FINAL DRAINAGE LETTER FOR LOT 2 CLAREMONT BUSINESS PARK 2 FILING NO. 2 EL PASO COUNTY, COLORADO

PCD File # PPR2345

REVISED

February 2023

EXISTING DRAINAGE MAP

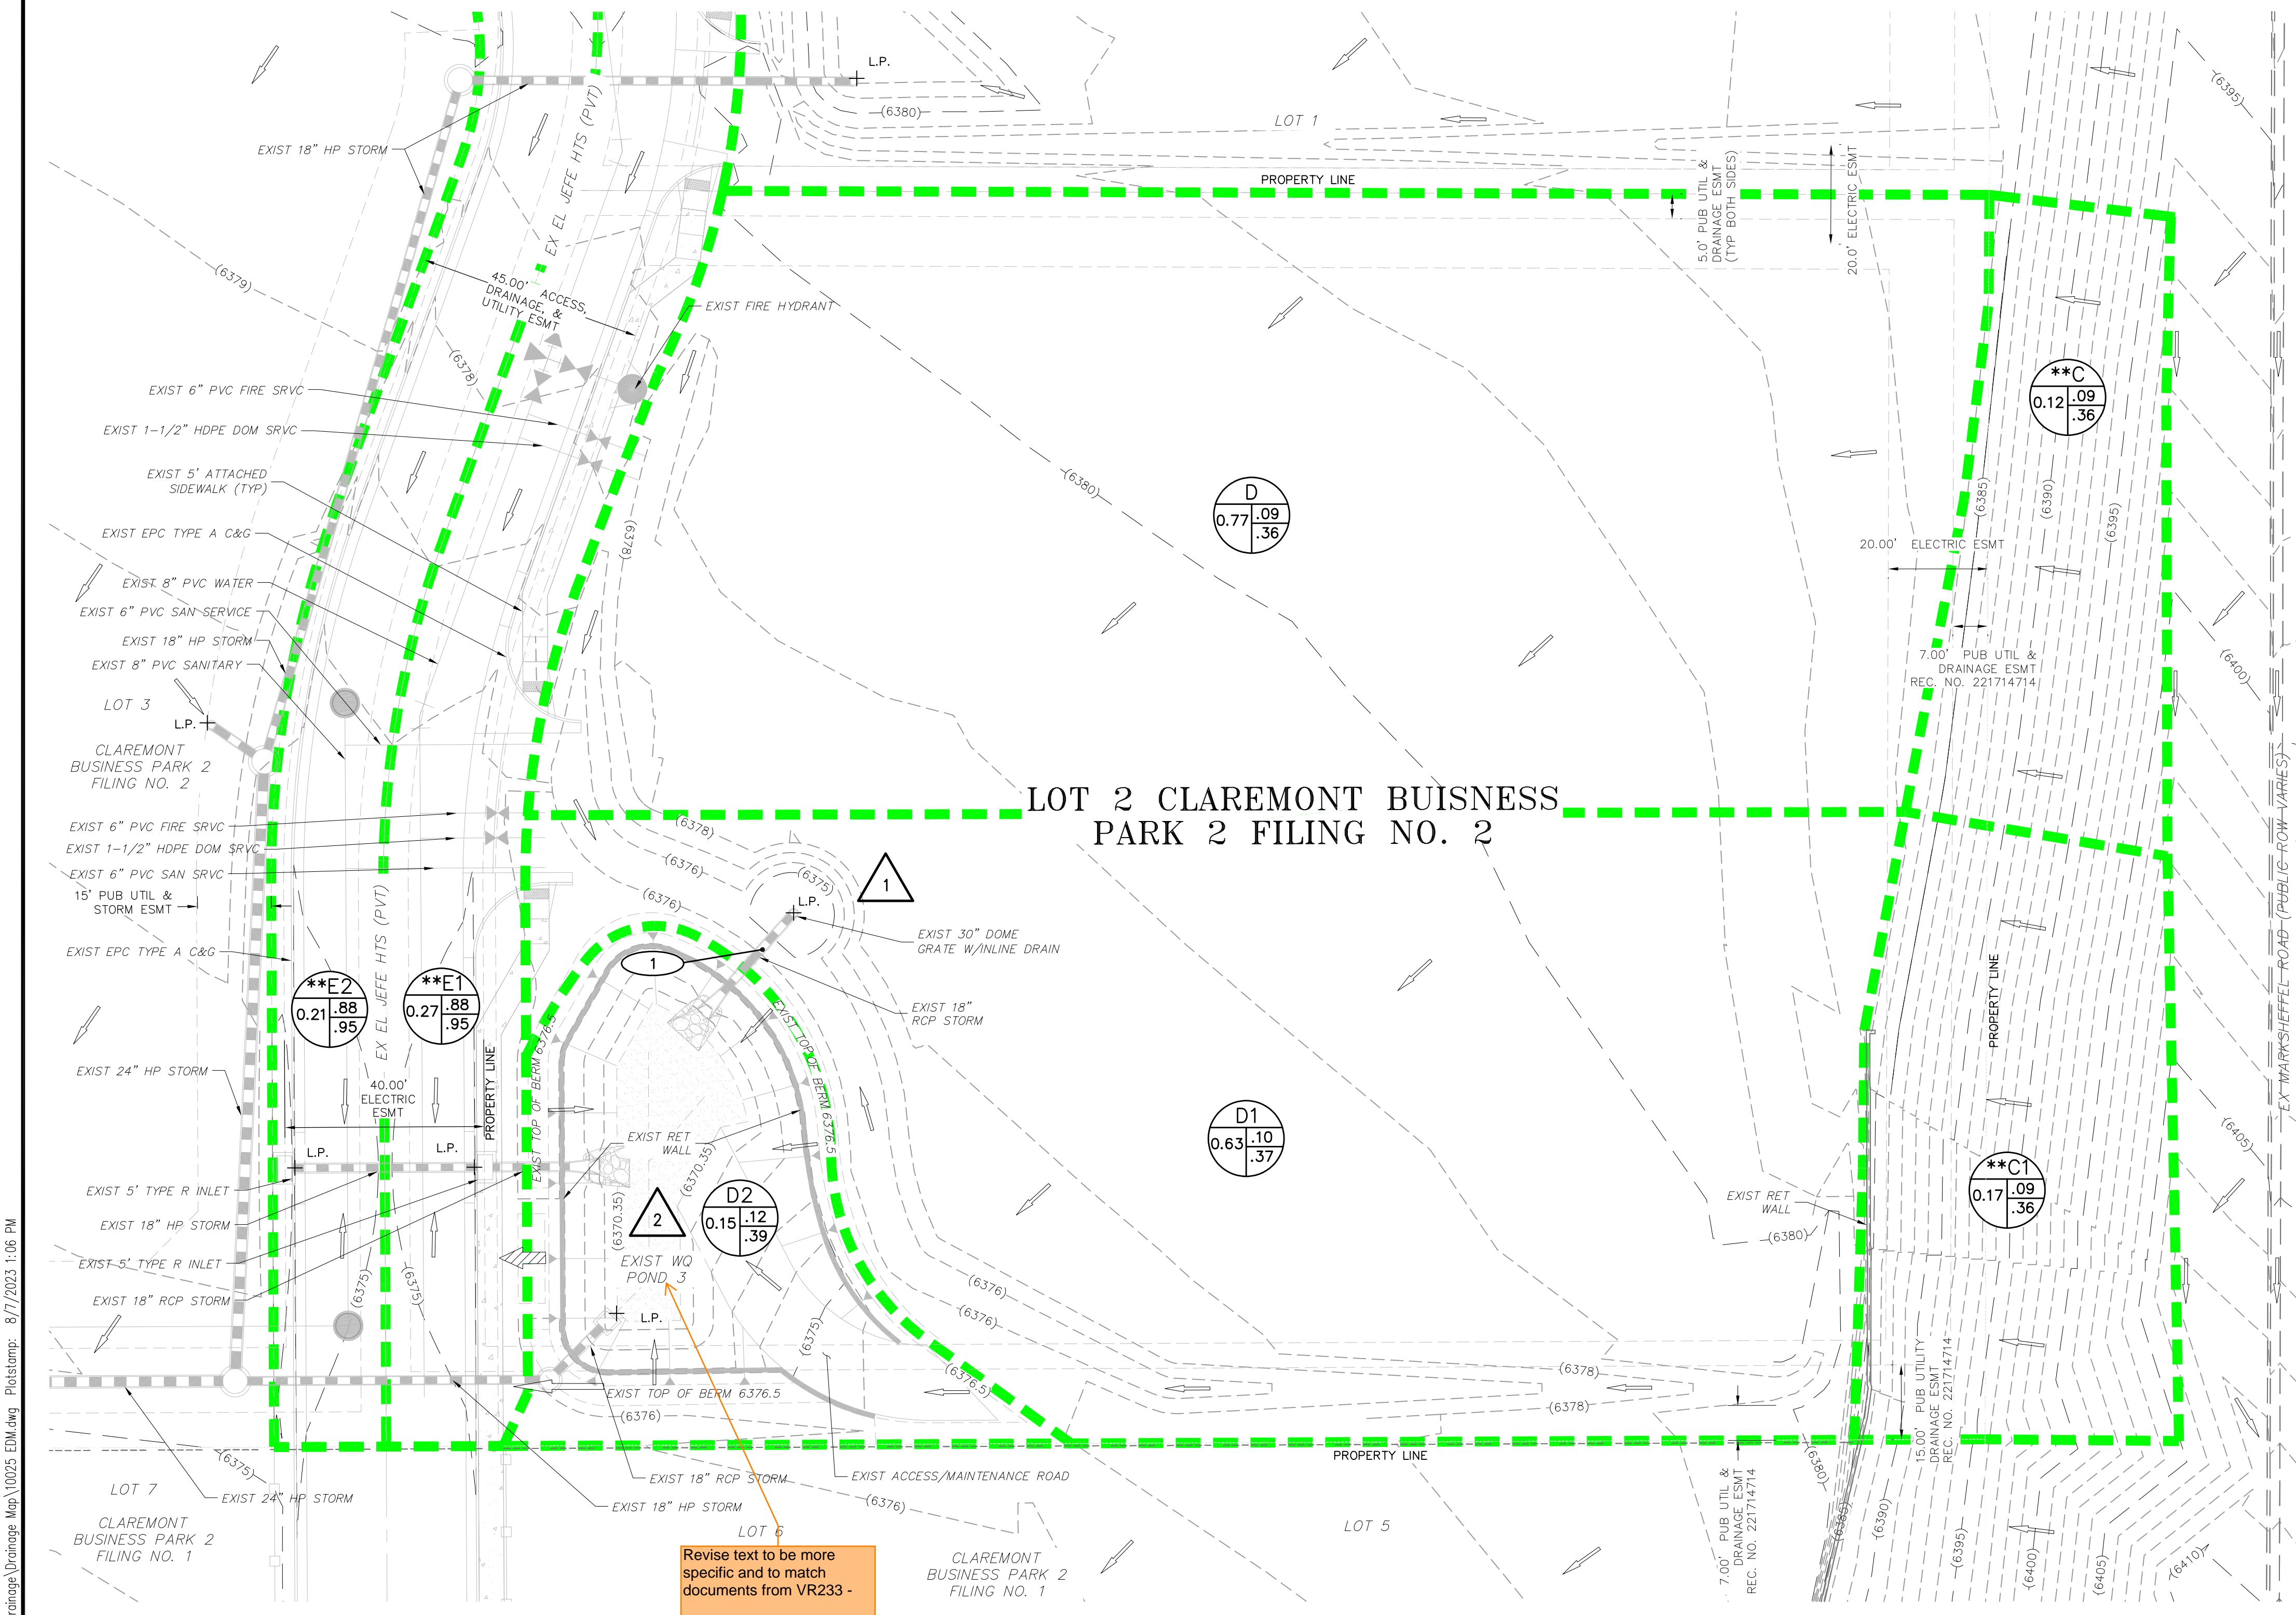
Revise text to be more specific and to match documents from VR233 -
"WQ Sand Filter Pond 3"

LABELED REVISED

POND 3 SAND FILTER DETENTION BASIN DATA

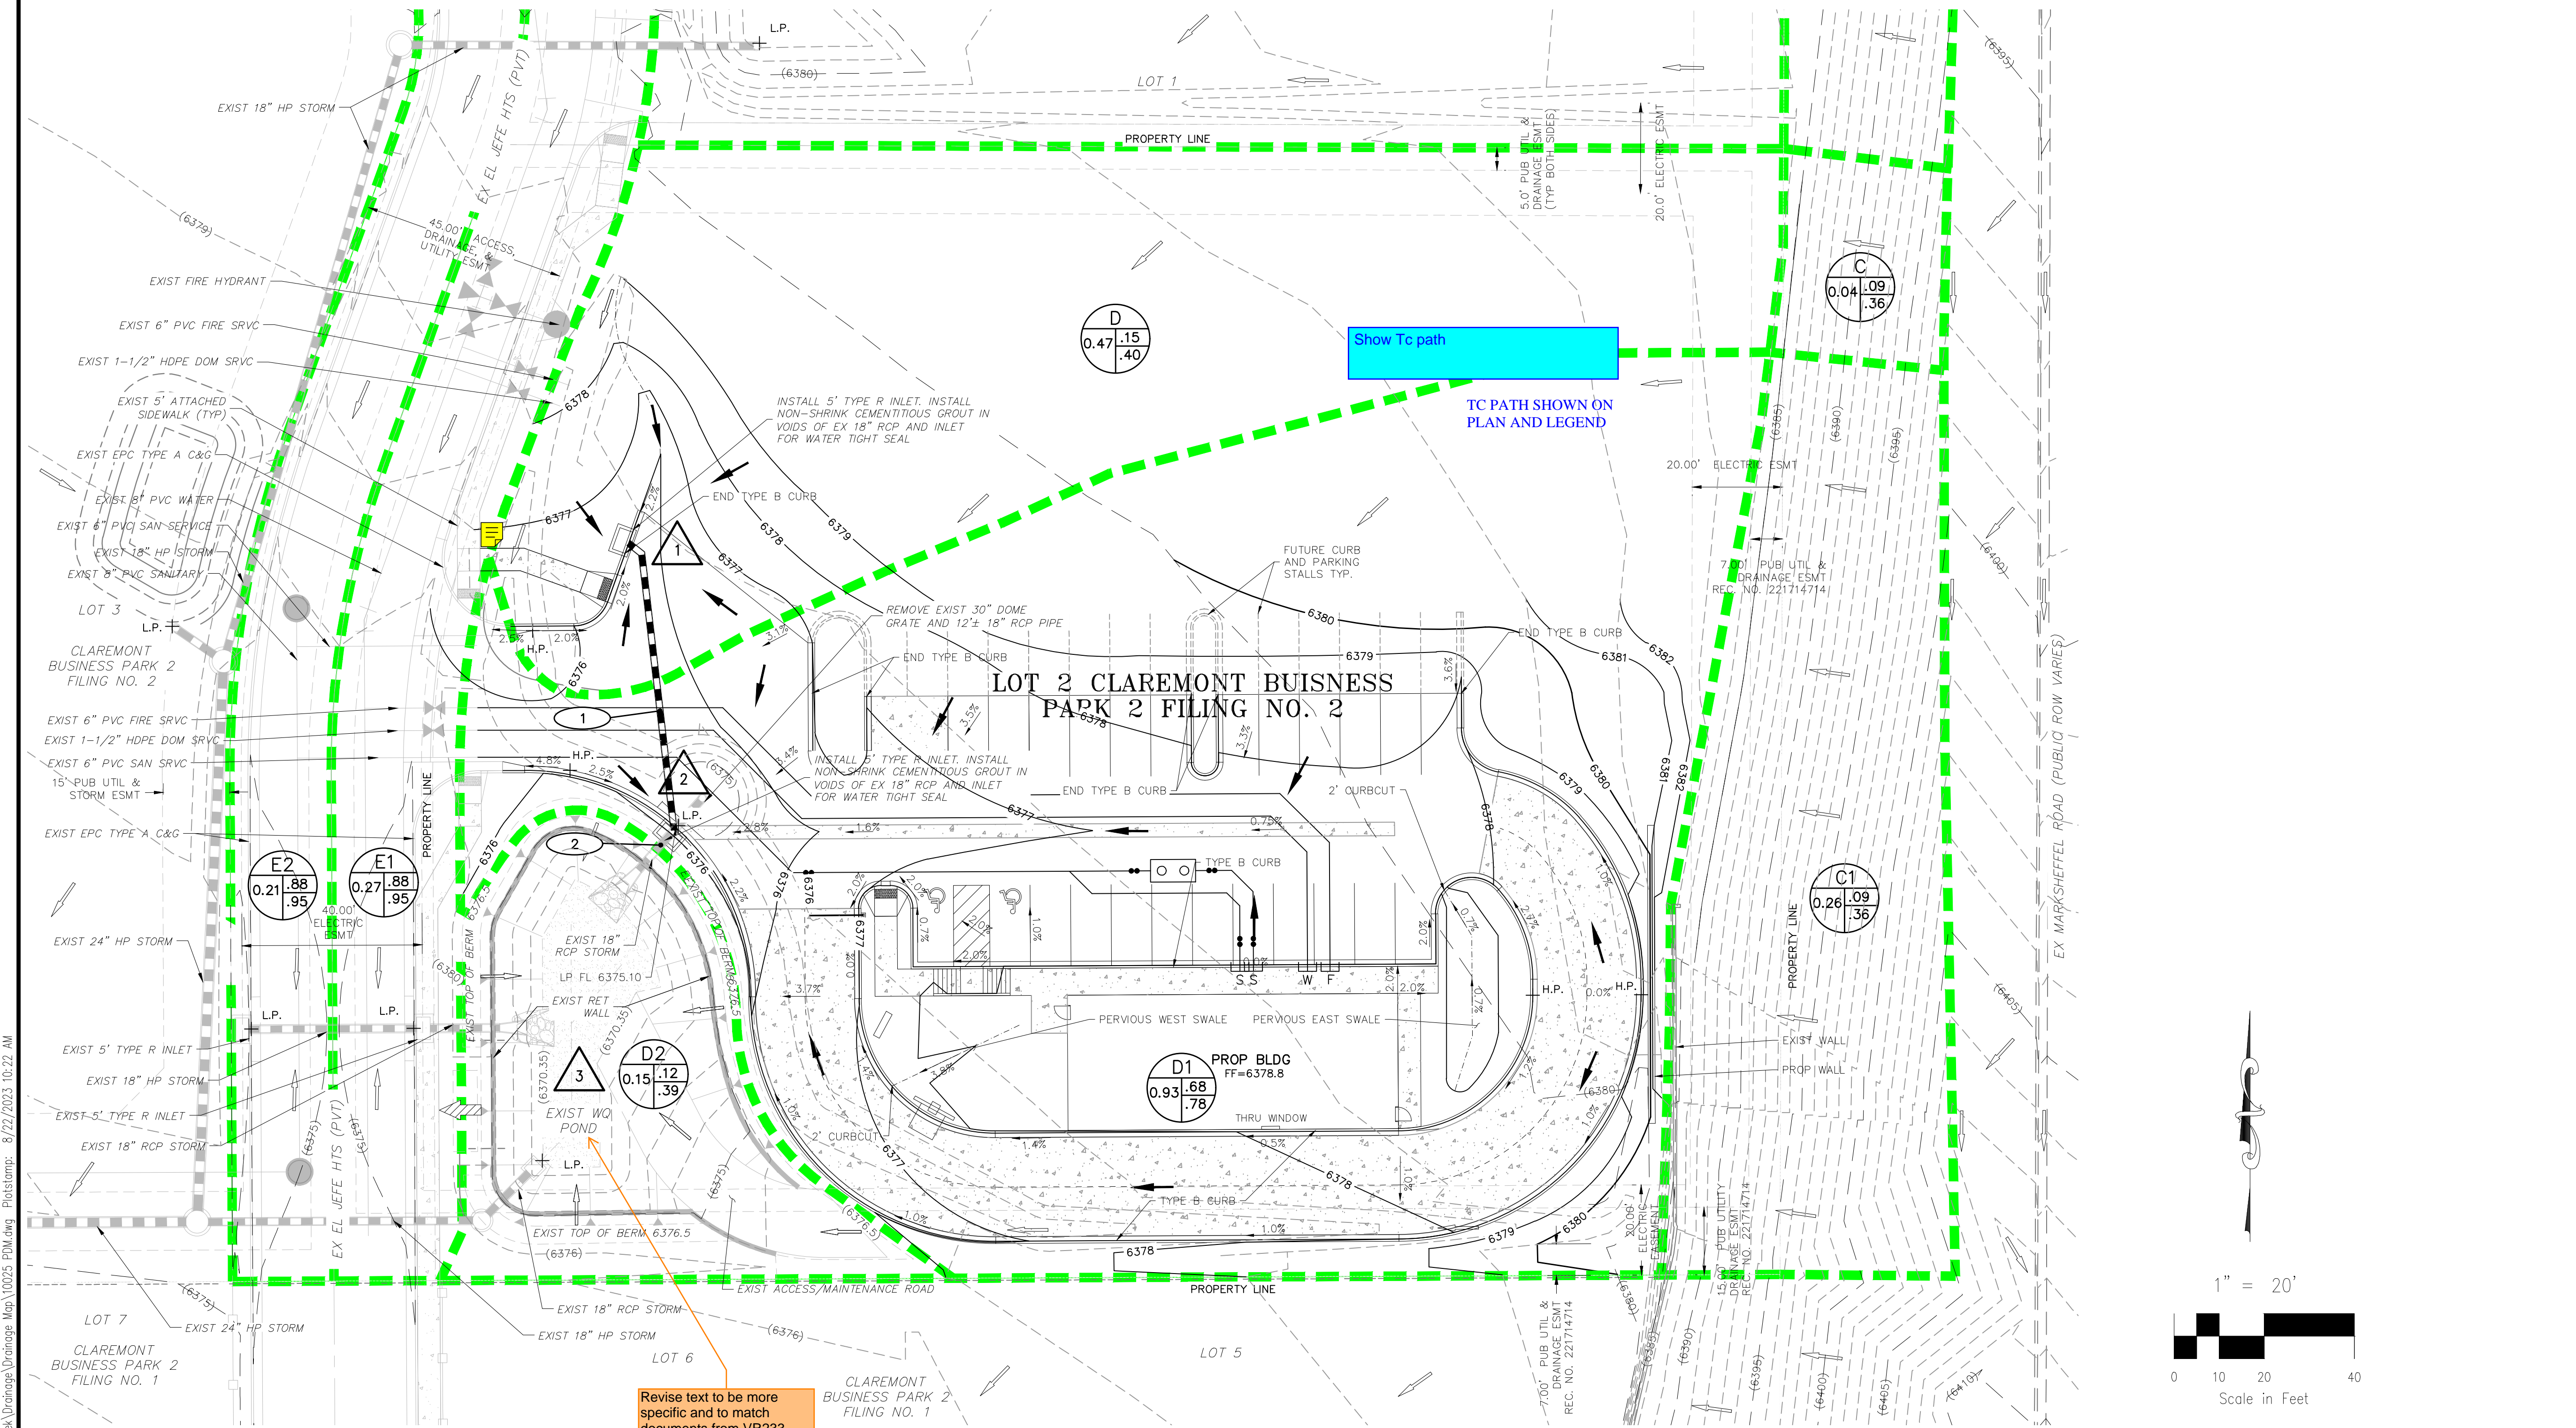
Revise text to be more specific and to match documents from VR233 - "WQ Sand Filter Pond 3"

LABELED REVISED
